SUBJECT: Safety Recall 19S54 – Supplement #2
 Certain 2006-2010 Model Year Fusion/Milan/MKZ/Zephyr Vehicles Equipped with Anti-Lock Brake Systems
 DOT 3 Brake Fluid and Anti-Lock Brake System Function

New! REASON FOR THIS SUPPLEMENT

FIGURE 10

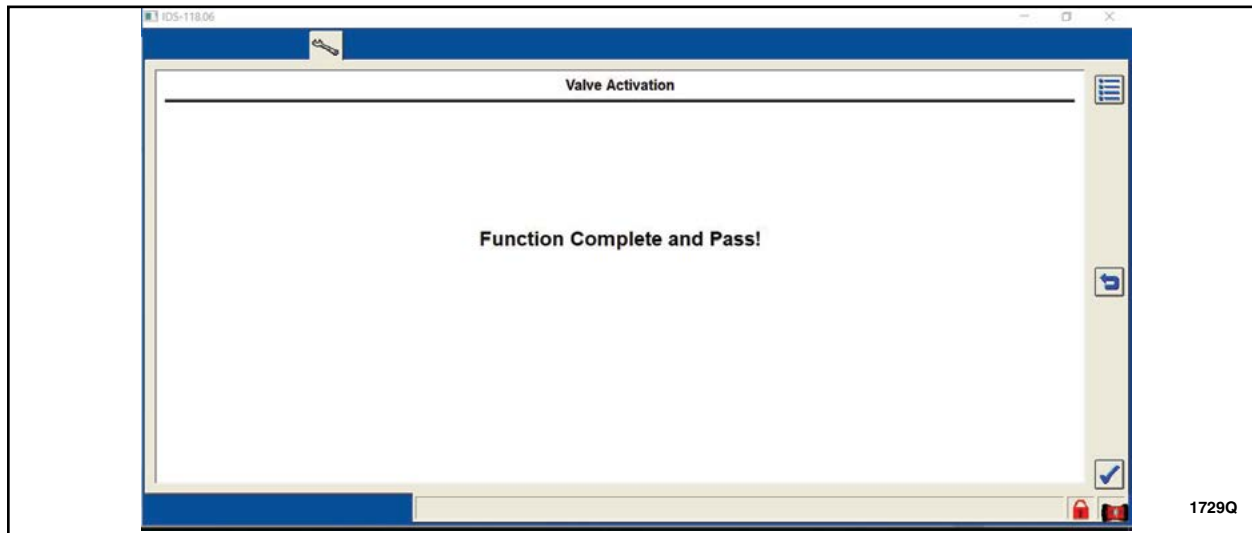
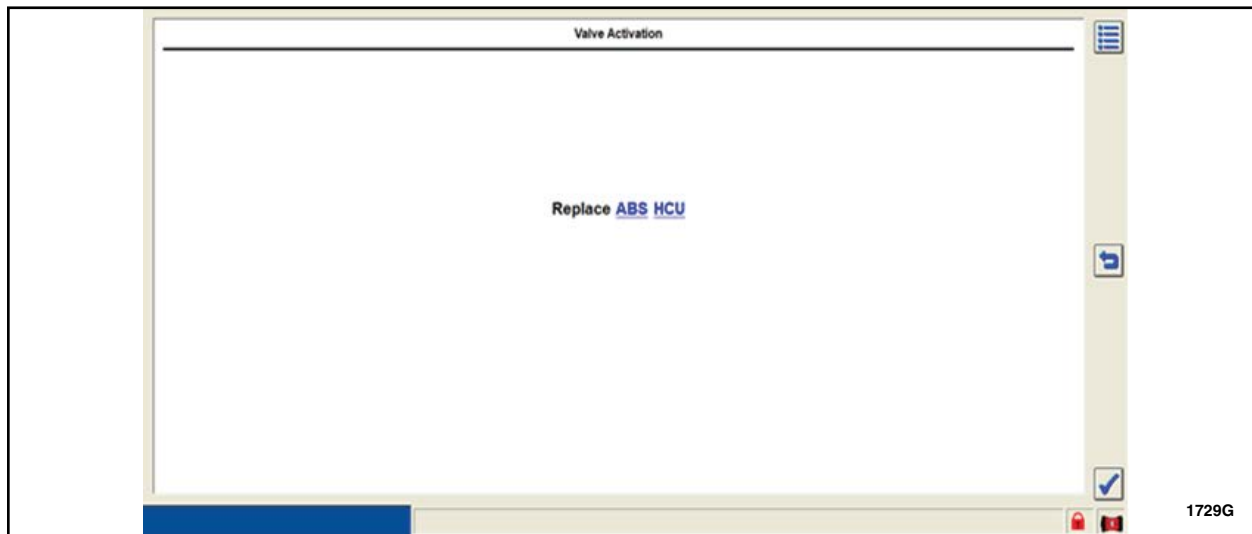
NEW ! NOTE: At the end of the IDS routine, after the activation of the valves has completed a total number of four times, you will receive one of the two possible screens shown below determining if the IDS routine has passed or failed. **The activation of the valves four times is completed within the IDS service function. Do NOT repeat the IDS Valve Activation routine multiple times - this is recorded in the IDS log file. SSSC contacts with multiple pass or fail results will not be approved, additional information will be requested.** See Figures 10 and 11.
